Access Compliance Report

Public Rights-of-Way

(Curb Ramps)

Intersection ID: 50339	Main Street: CASTLECOVE_RD	Cross Street: PAISLEY_ABBEY_LN	Location: SW
ADA ID: 89CCE621C33F	Ramp Type: PerpDiag	Initial Pass/Fail: Fail	Overall Compliance: No
Severity Score: 33.75			
Codes/Mitigation Info/Possible Solution		Field Measurements/Component Compliance

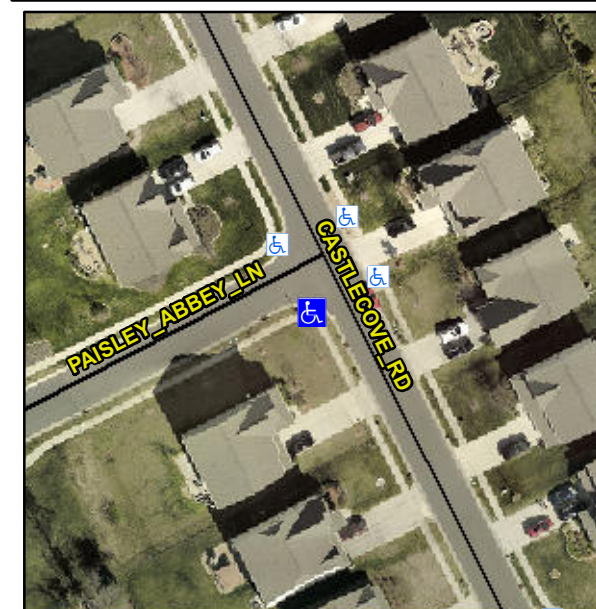
R304.5.1, R304.5.3

Remove & Replace Curb Ramp With Two New Directional Ramps or Equivalent.
